CHALLENGER OF RECORD & DEFENDER AMERICA'S CUP 36

Interpretation 008 of AC75 Class Rule Version 1.2 issued 10 December 2018

Fig 2a: Penetration not constituting opening

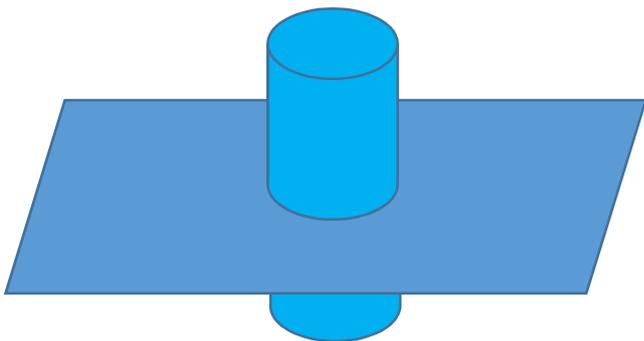
2. In geometric understanding, a penetration occurs, when an area is intersected (pierced) by either a volume (e.g. a solid cylinder) or the areal envelope of a volume (e.g. a hollow cylinder). This action fulfils the definition of the OED, where the intersecting object is penetrating, piercing or passing through something (the initial area).
 - a. By this penetration, the initial area is reduced by the intersectional area (as in 1.), but no opening occurs, when the penetrating object is a volume.
 - b. An opening occurs only, if the penetrating object consists of the lateral surface of a volume, having two open ends (e.g. a hollow cylinder)

1. Penetrations by **control systems** or instrumentation cables which are practically completely filling the volume by **control systems** or instrumentation cables and as described in preface B.2. fulfil stipulation of preface B.2.a and do not constitute openings for the purpose of the dimensional area, areal and location constraints of Rule 20.4.
2. Penetrations by **control systems** or instrumentation cables which are not practically completely filling the volume by **control systems** or instrumentation cables and as described in preface B.2., fulfil stipulation of preface B.2.b and constitute openings for the purpose of the dimensional area, areal and location constraints of Rule 20.4.
